Lewis County Public Works
Chehalis, Washington 98532
May 5, 2023

**Kruger Road MP 1.20 Culvert
Replacement Project, CMP 1904
Addendum No. 1**

Attachments: Addendum #1, Page 2 of 2 – Revised Staging Area

ADDENDUM 1
05-05-2023 (PAGE 2 OF 2)
LEWIS COUNTY APPROVED:

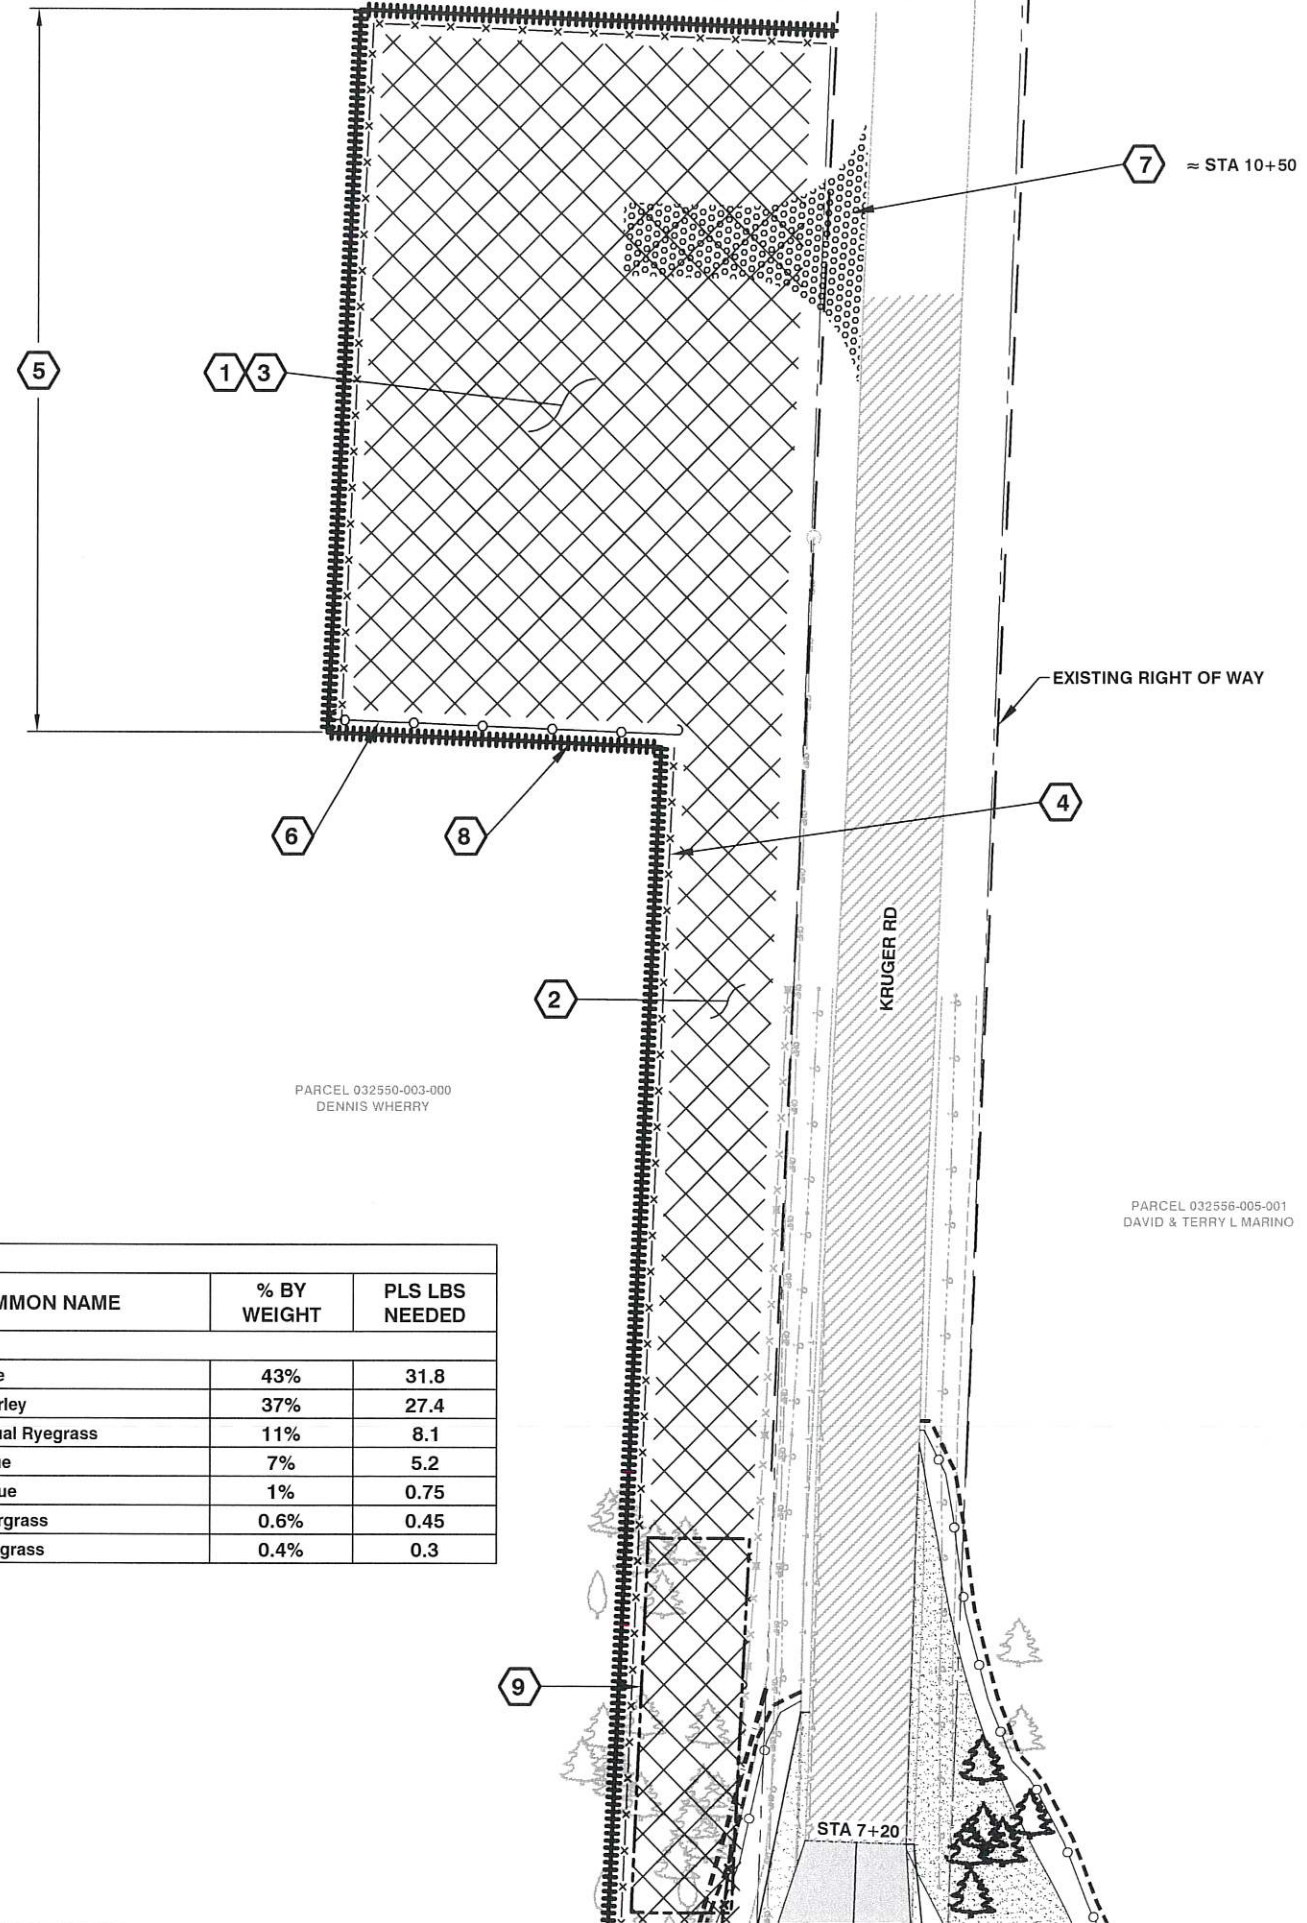
The Kruger Road MP 1.20 Culvert Replacement Project provided staging area has been relocated. Contract Plan Sheets C-101 (3 of 16) and C-401 (14 of 16) depicting the Staging Area at Kruger Road Station 2+50 Lt. shall be deleted from this Contract. Any and all Contract Plan or Contract Special Provision references to the Staging Area and any work associated with the Staging Area at Station 2+50 Lt. (Parcel #032552-003-002, Christopher and Katherine Kouri) shall be transferred to the revised Staging Area at Kruger Road Station 10+00 Lt. (Parcel #032550-003-000, Dennis Wherry) per Page 2 of 2 of this Addendum.

The revised Staging Area at Kruger Road Station 10+00 Lt. (Parcel #032550-003-000, Dennis Wherry) includes a 30-ft wide access way from the northern project limits to the Staging Area for equipment access outside the paved roadway surface designated to remain. If the Contractor elects to utilize this 30-ft wide access way, twenty Douglas fir trees recently planted for reforestation shall be replaced per the Tree Riparian Mix requirements in the Contract Plans. All disturbed areas within the Staging/Access Areas shall be restored as indicated on Sheet 2 of 2 of this Addendum. All work associated with restoration of the Staging/Access Area shall be included in Bid Item No. 20 Planting Mitigation Construction.
